WBN-TS-03-12

WATTS BAR NUCLEAR PLANT (WBN) – LICENSE AMENDMENT (WBN-TS-03-12)
MONITORING OF CONTROL OR SHUTDOWN ROD POSITION BY AN ALTERNATE
MEANS

**PROPOSED LICENSE AMENDMENT REQUEST WBN-TS-03-12
DESCRIPTION AND EVALUATION OF THE PROPOSED CHANGE**

Figure 2 – Proposed Monitoring of Stationary Gripper Coil

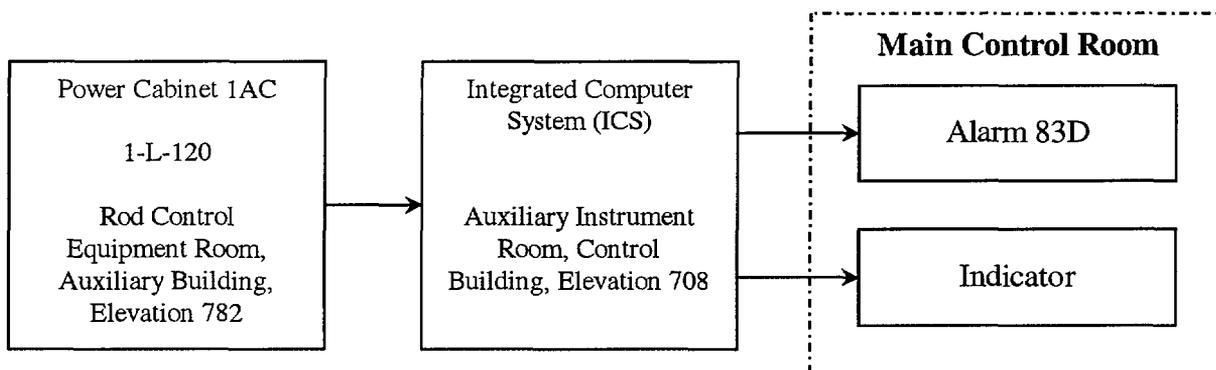
TVA plans to utilize the plant computer to monitor the stationary gripper coil voltage. Monitoring the inoperable ARPI in this manner will allow for historical data retrieval and will also allow the use of the existing rod deviation alarm. The “Rod at Bottom” status light and the “Rods at Bottom” annunciator for the affected control rod may be disabled. A simplified schematic of the monitoring circuit is provided below in Figure 2:
